**BCC DS**  
**RECEIVED**  
08-MAY-2026  
**APPLICATION REF**  
A007020190

DA Set - 21.02.2024.

DA Set - 15.02.2026.

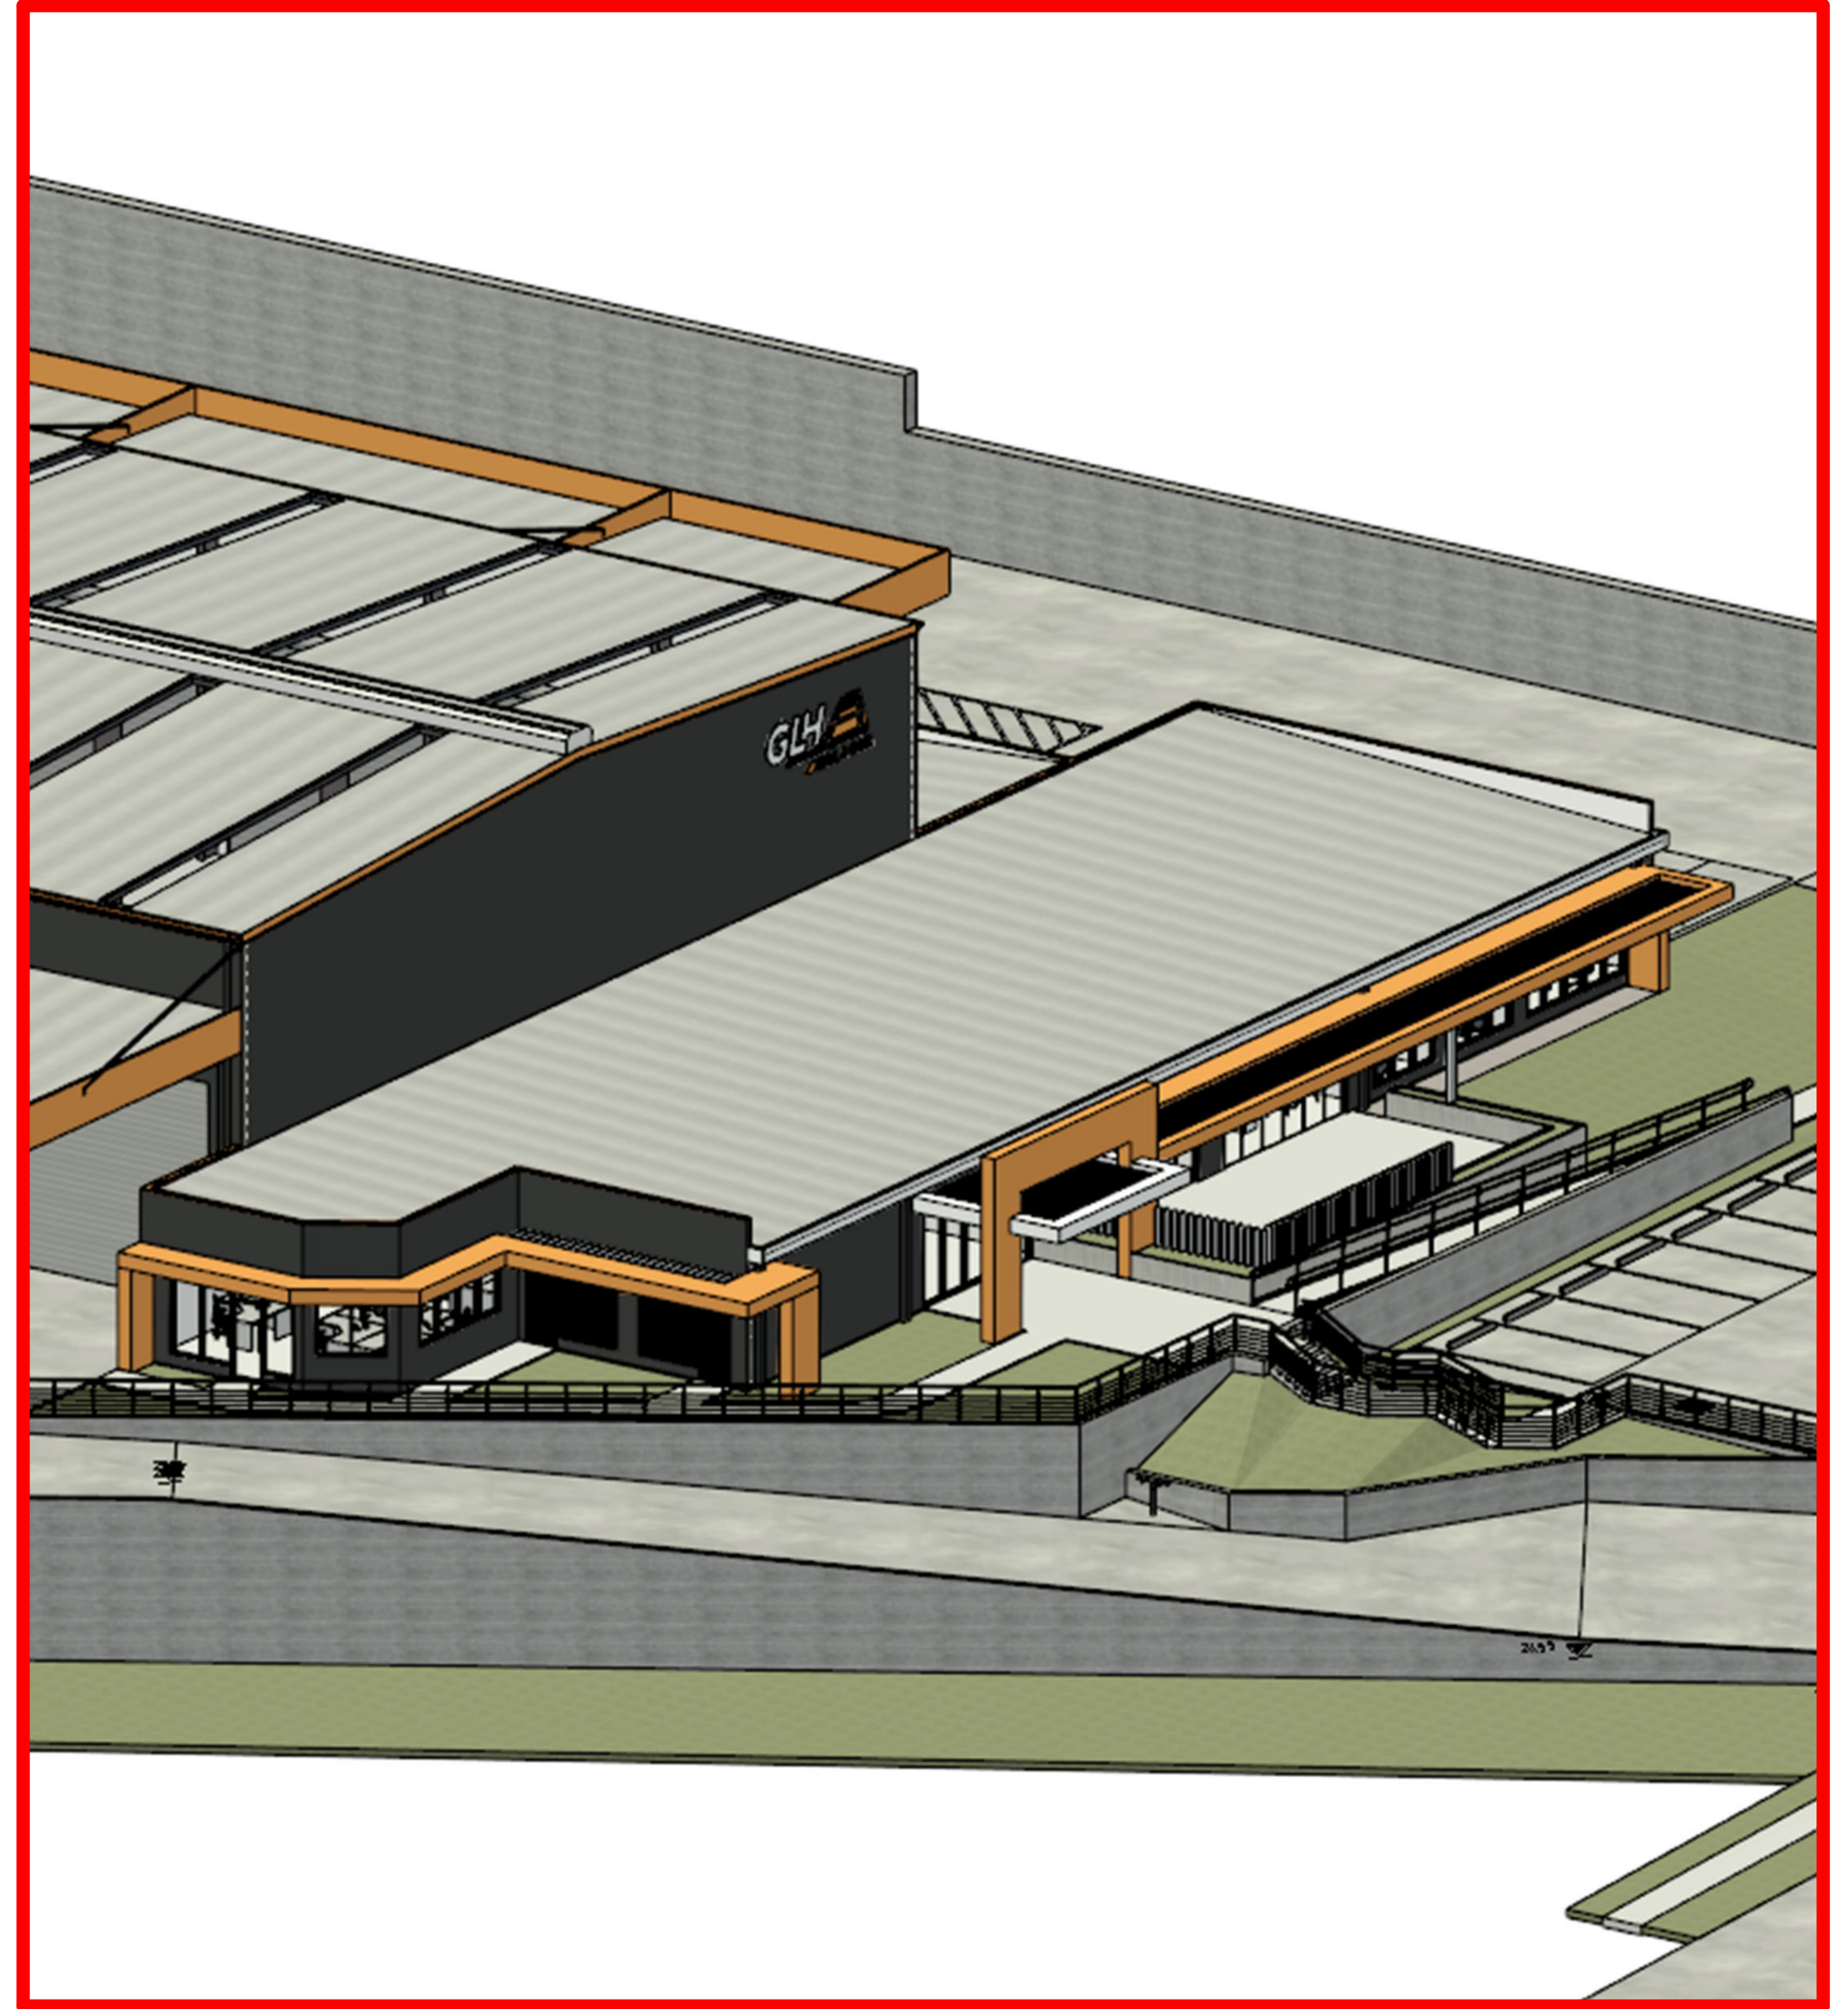
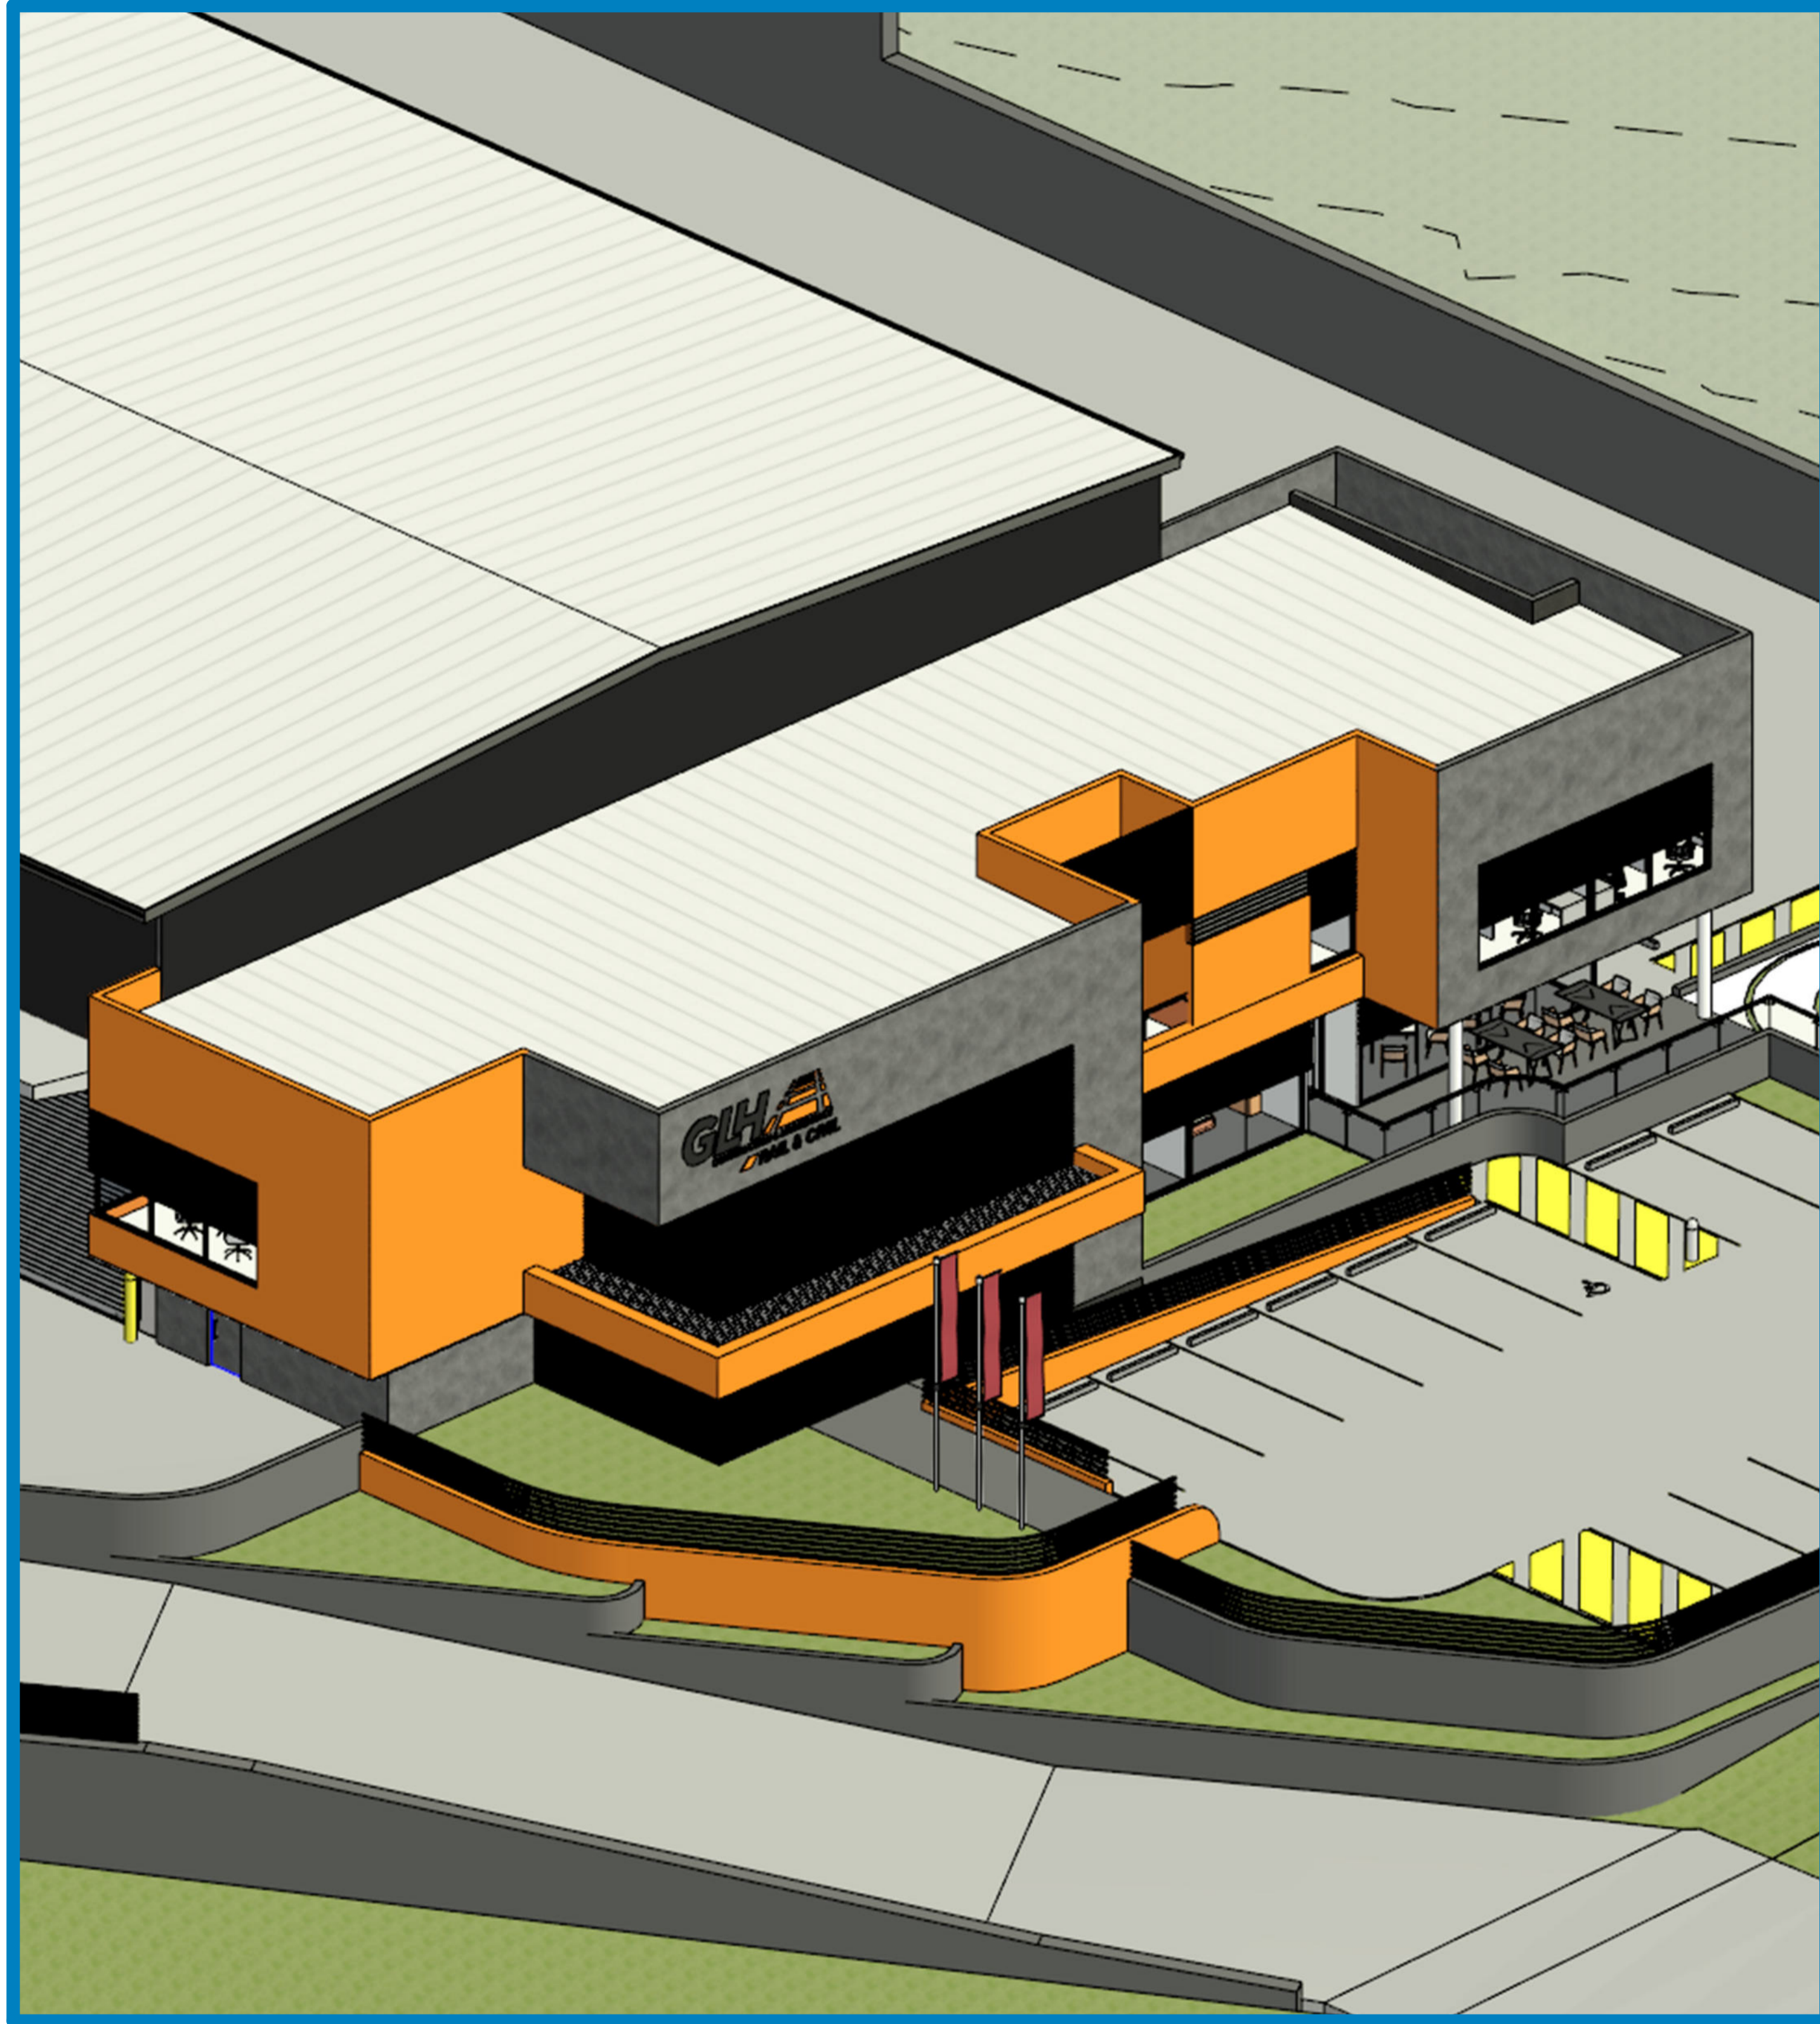
01. The entire building has been set back further from the street.

Rev\_02

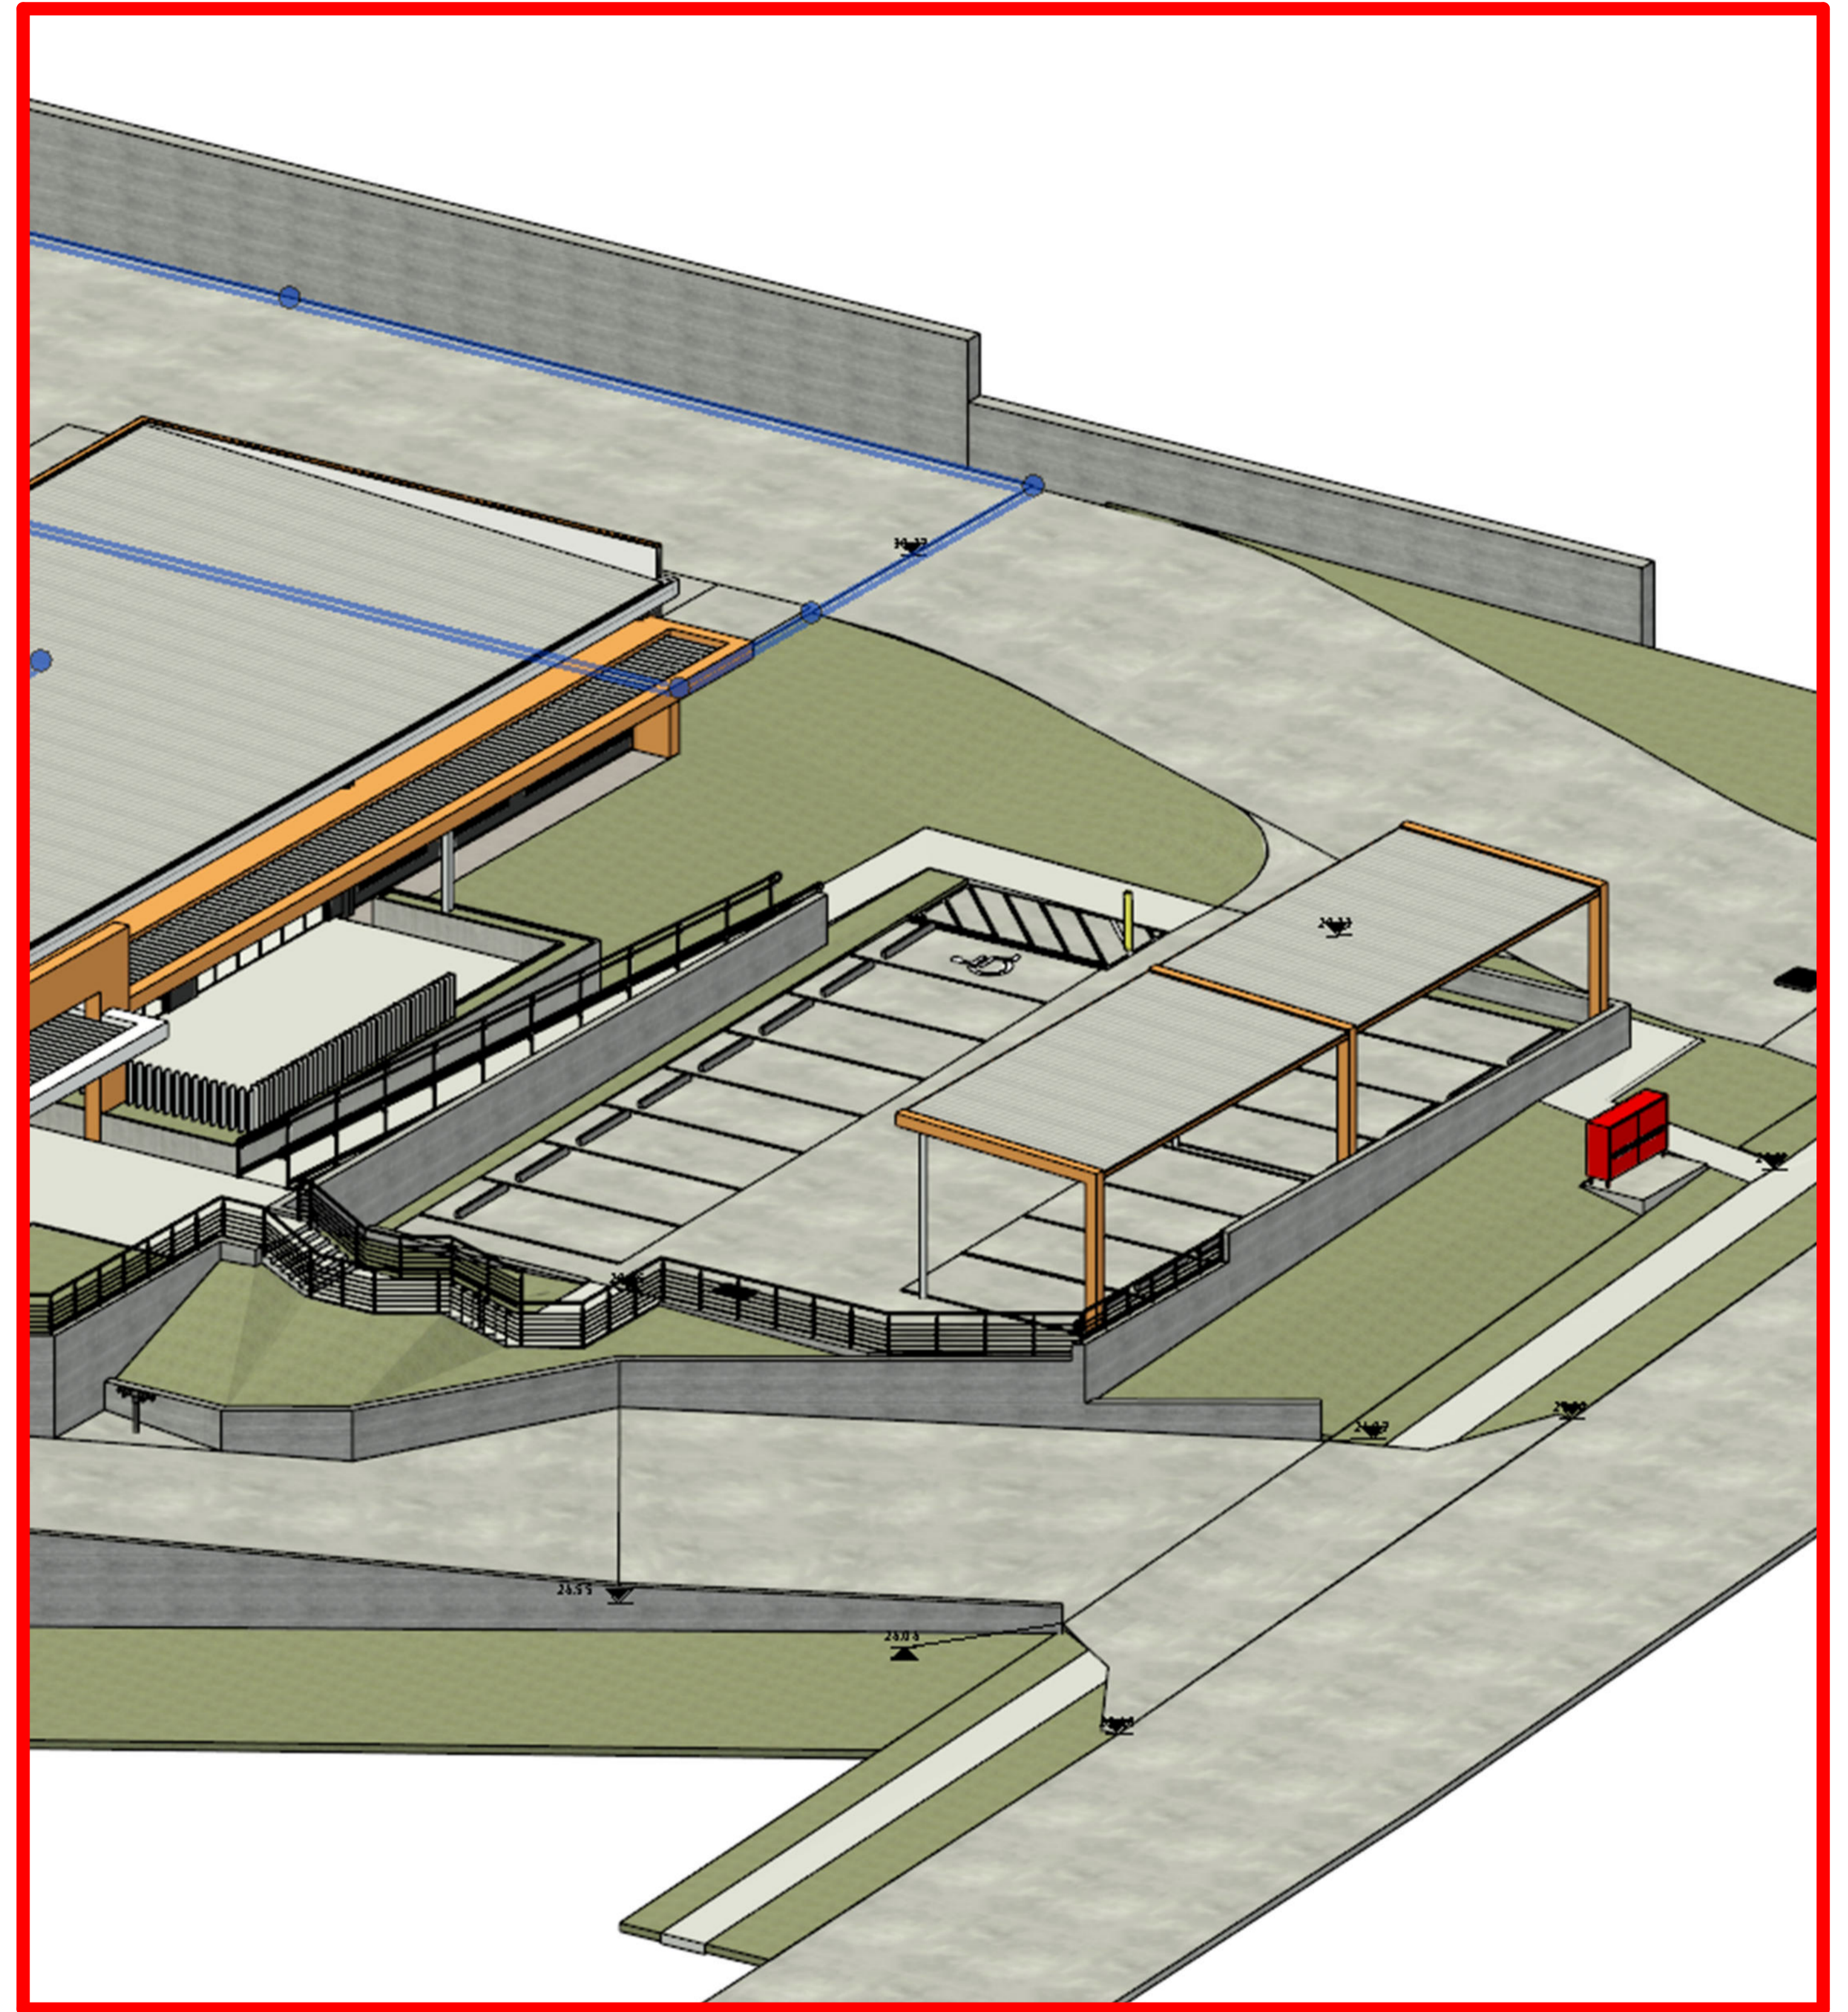
02. The front office section has been revised from two storeys to a single ground floor level.

03. The site layout, including landscaping and footpaths, has been completely redesigned.
